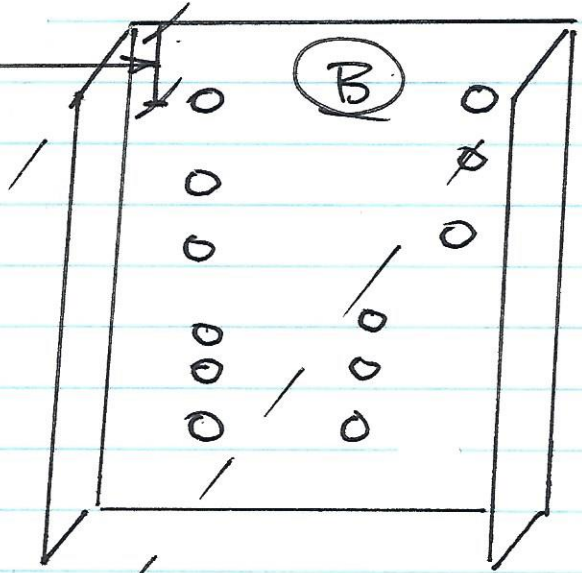
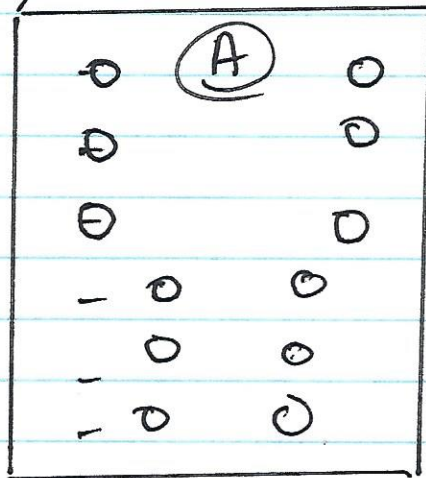
THE MOUNTING BOLTS NOT TO GO THROUGH
A+B PLATE AS ONE BOLT

B PLATE
TOP TO CL FIRST HOLE
EXAMPLE 1"

B PLATE
TOP TO CL FIRST
HOLE

WELD A TO B.

$\frac{1}{2}$ " MATERIAL

RELIEF FOR ORIGINAL
TRANSOM WELD
AREA
